## **WYNNFIELD SUBDIVISION,**

### **UNIT 5**

APPLICATION NUMBER 1 DATE July 9, 2015

# DETAIL SITE PLAN

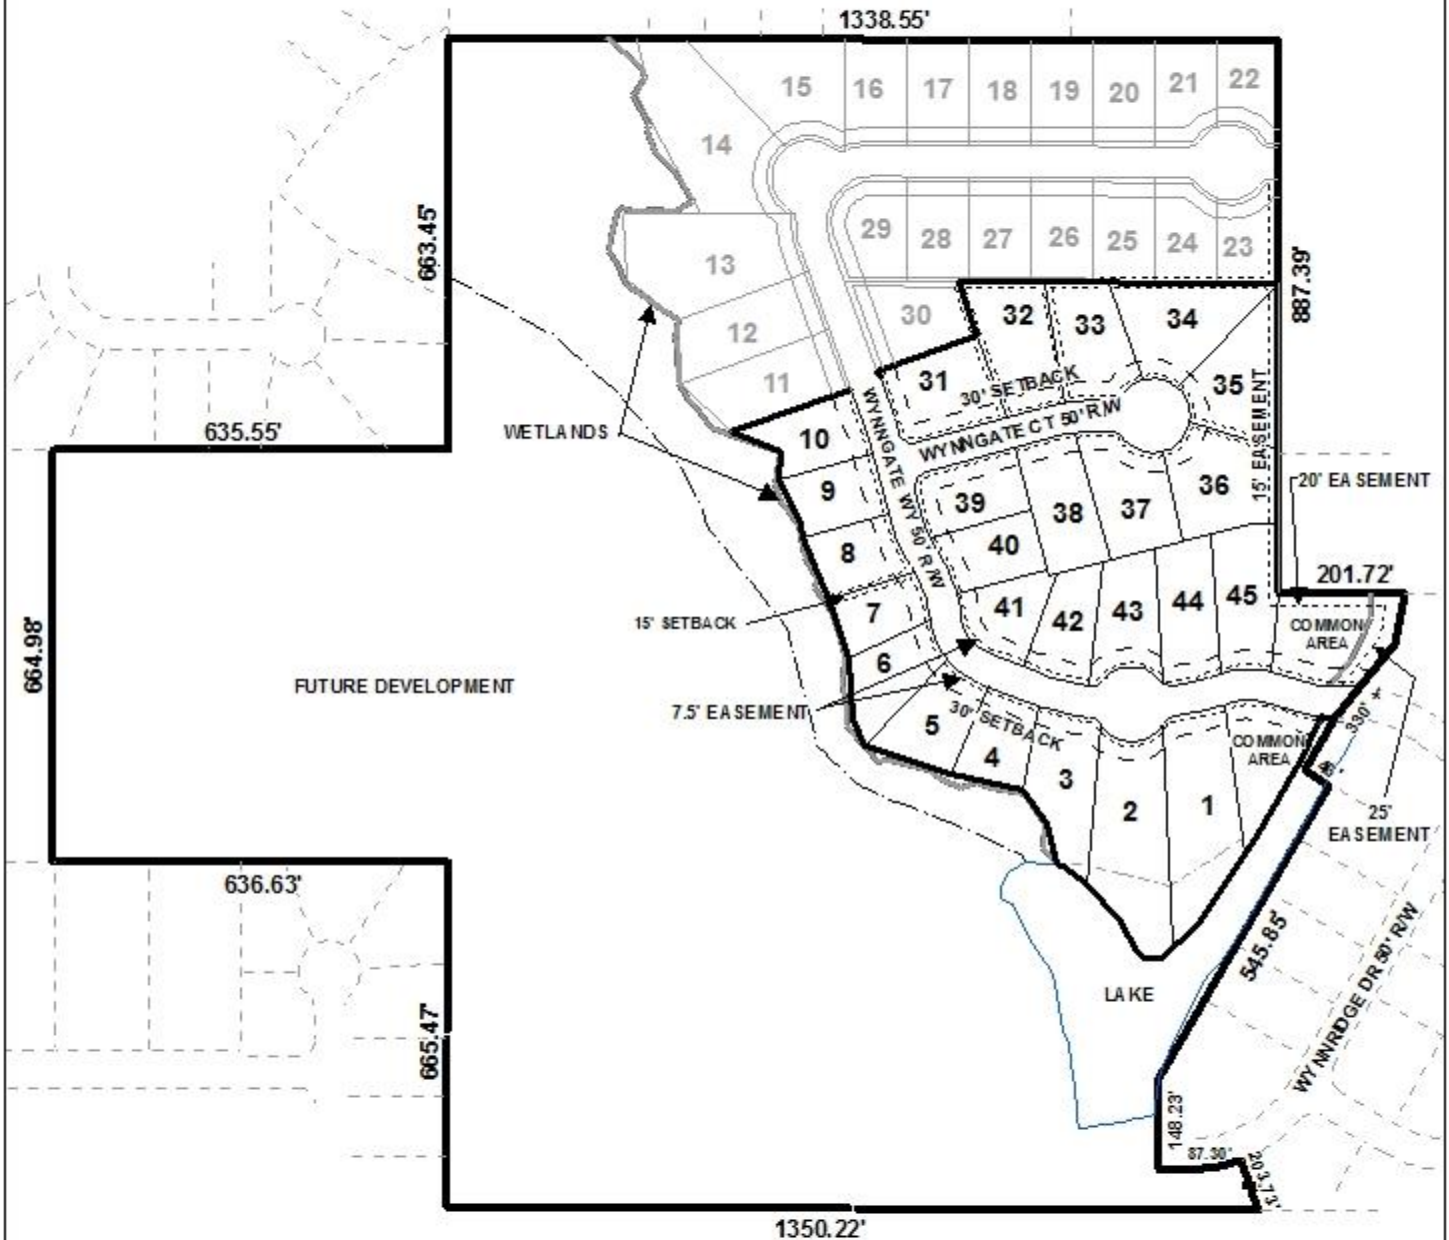
- D. Add street names to the vicinity map.
- E. Label the area enclosed by the curves #14 – 17 (located between Lots 2 and 43). Is it Common Area?
- F. Provide an updated Plat for review after revising the centerline of Wynngate Way to meet the requirements the Subdivision Regulations.

- G. Review and revise the written legal description to include a written bearing and distance near Lot 6.
- H. Correct the Subdivision Name from “Wynnfiend” to “Wynnfield”.

Traffic Engineering Comments: Per Section V.B.12 of the Subdivision Regulations, the alignment of Wynn gate Way from Curve 4 to Curve 6 should be modified to eliminate the series of reverse curves with no 100 foot tangent in between. Driveway number, size, location and design to be approved by Traffic Engineering and conform to AASHTO standards.

The site abuts three street stubs: Wynnridge Drive, Wynngate Way, and Widgeon Drive – all with compliant 50' right-of-way width. The preliminary plat depicts the continuation of Wynngate Way along with the construction of Wynngate Court. The right-of-way width of all proposed streets within the subdivision is 50', as compliant with Section V.B.14. of the Subdivision Regulations. The proposed turnarounds at the terminus of both Wynngate Court and Wynngate Way are depicted with 120' right-of-way widths, also compliant with the Subdivision Regulations. If approved, all streets must be constructed to City of Mobile standards, and be accepted by the City of Mobile for maintenance prior to the signing of the Final Plat. A note should be placed on the Final Plat limiting all proposed lots to one curb-cut each, with the size, design and location to be approved by Traffic Engineering and conform to AASHTO standards.

It should be pointed out that the proposed subdivision site abuts two adjacent landlocked parcels to the east and west of the site. The preliminary plat depicts a proposed street stub to the east adjacent to the proposed Lots 22 and 23; however, it appears that the landlocked parcel abuts property to the south and southeast within the Isle of Palms Subdivision (which is accessed by private streets) that is under ownership by the same family or corporate entity, thus access to the parcels should not be required for the application at hand. The plat should be revised to depict only a cul-de-sac at the eastern terminus of the proposed street.

*As currently proposed, the revised plat depicts a cul-de-sac at the eastern terminus of the proposed Wynngate Way adjacent to the proposed lots 20-25; however, the plat still does not depict connectivity to the southern terminus of Widgeon Drive of the adjacent subdivision to the north. The provision of a street stub is also not illustrated to the south and west of the site to ensure connectivity with the Raleigh Subdivision and the landlocked parcel to the west. Furthermore, the applicant has still not submitted an overall site layout for the area reserved for future development, in compliance with Sections I.B.1. and I.C.2. of the Subdivision Regulations regarding orderly development and health and safety. As proposed, all lots would be served by one access point and would not appear to comply with the International Fire Code requirements, as adopted by the City of Mobile.*

- 4) Revision of the plat to depict only a cul-de-sac at the eastern terminus of Wynngate Way, adjacent to the proposed Lots 22 and 23;
- 5) Revision of the Subdivision name on the plat from "Wynnfiend" to "Wynnfield";

- 7) Revision to reflect Traffic Engineering comments: *(Per Section V.B.12 of the Subdivision Regulations, the alignment of Wynngate Way from Curve 4 to Curve 6 should be modified to eliminate the series of reverse curves with no 100 foot tangent in between. Driveway number, size, location and design to be approved by Traffic Engineering and conform to AASHTO standards.);* and
